**TOWN OF BROOKLYN
PLANNING AND ZONING COMMISSION
Regular Meeting Agenda
Wednesday, September 2, 2020
6:30 p.m.**

**TOWN OF BROOKLYN
PLANNING AND ZONING COMMISSION
Regular Meeting
Tuesday, August 18, 2020
6:30 p.m.**

Engineering Plan Review Pertaining to Proposed Gravel Excavation

PAUL R. LEHTO
(RIVER WALK DRIVE)
BROOKLYN, CT

DATE: 6/2/2020 DRAWN: DJH
 SCALE: 1" = 150' DESIGN: DJH
 SHEET: 3 OF 7 CHK BY: ---
 DWG. No: HF 310 JOB No: 173055

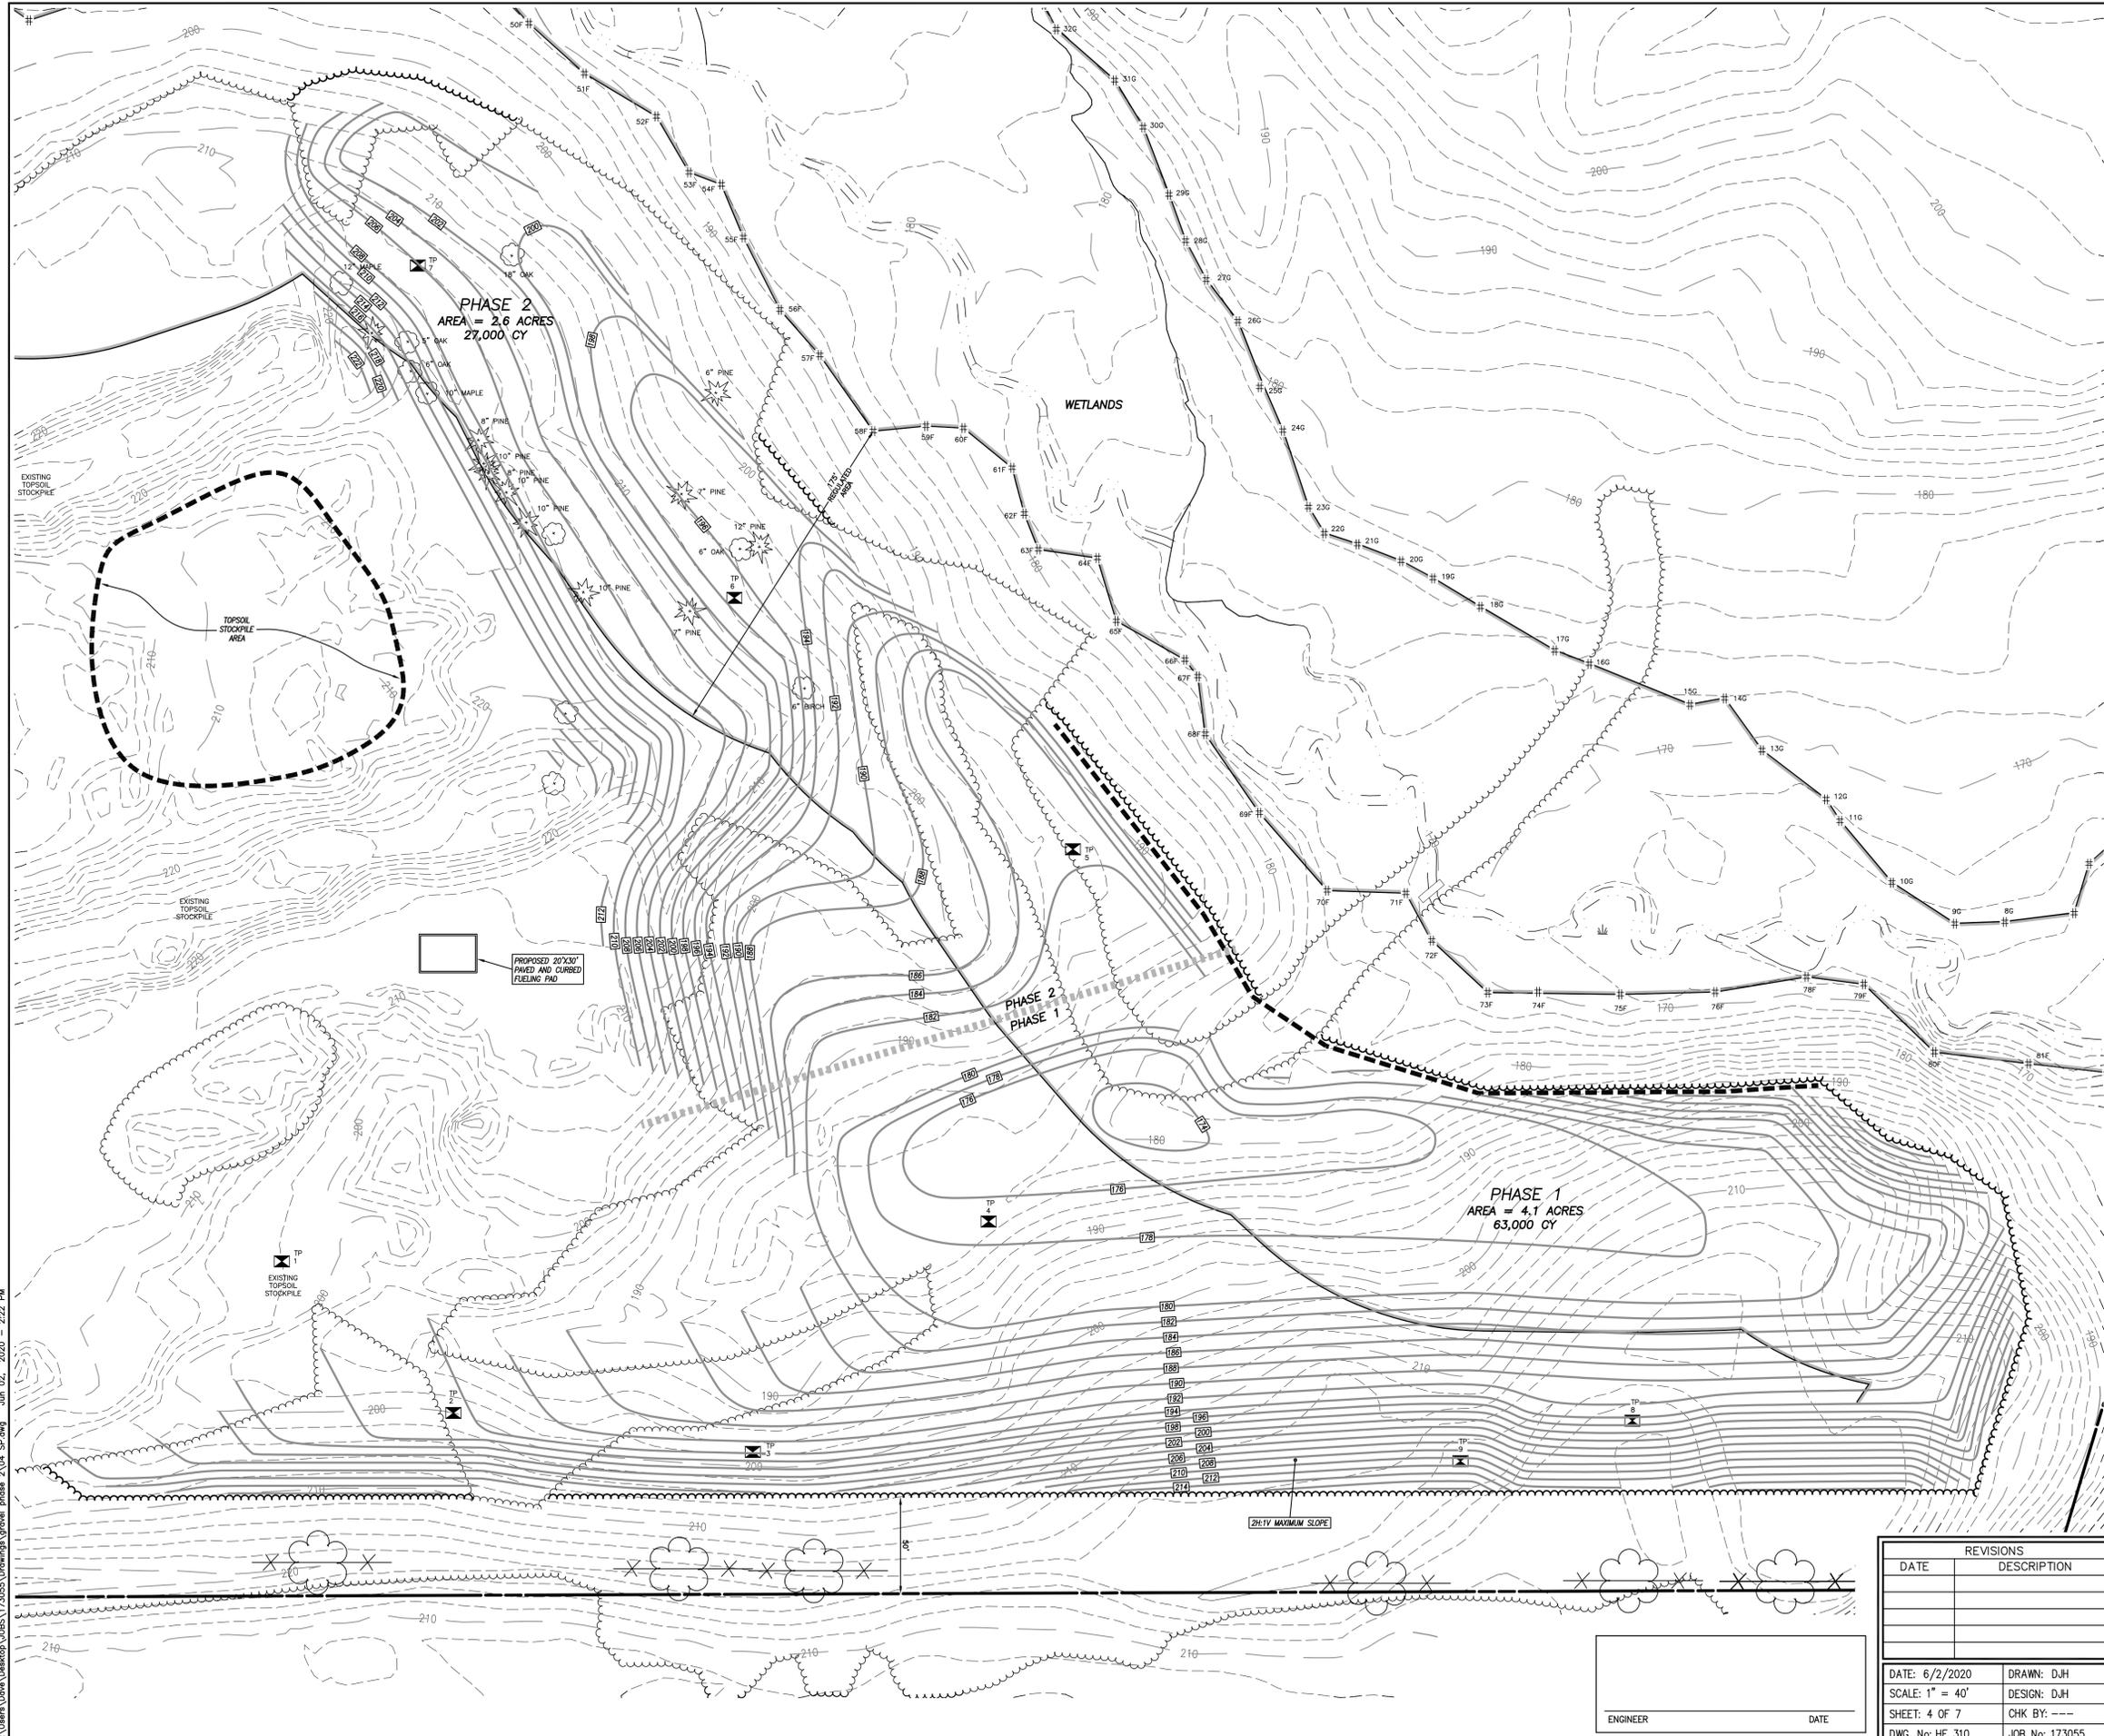
3. The haul road running through the previously excavated area to River Walk Drive (see Sheet 2 of 7) crosses a wetland. It is recommended that the Applicant's engineer evaluate and describe the crossing, which has been in place for many years, to determine if it is in good condition for future heavy loads and if any erosion has occurred around it that would require some reconstruction. Additionally, it is important to establish erosion and sediment control systems on both sides of the crossing and other methods to help protect the wetlands from the heavy truck traffic, dust, and material that may fly off haul trucks. Erosion and sediment control system(s), if required, should be shown for the affected area on a plan at a scale of no less than 1" = 40'.
